Product: **Shutter Actuators JA/S**

Type: **JA/S 2.230.1, JA/S 4.230.1, JA/S 8.230.1,
JA/S 4.230.1M, JA/S 8.230.1M, JA/S 4.24.1, RA/S 4.230.1**

Current application program:

1. Conversion

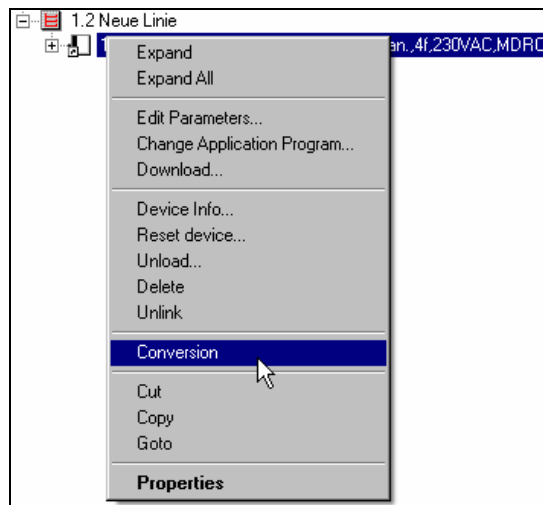
Version 2.3 offers the possibility to take over parameters and group addresses from older versions (from version 2.0) of the application (only with ETS 3). Therefore the effort on parameterisation can be minimized. See succeeding steps how to start conversion:

- Click with right mouse key on the device (JA/SX.XXX.X) in ETS 3
>> The sub menu with the menu option "Conversion" is faded in:

- Click on “Conversion”.
>> The dialog window for starting the conversion is faded in.
- Click on „Adopt previous program version“ and follow the instructions.
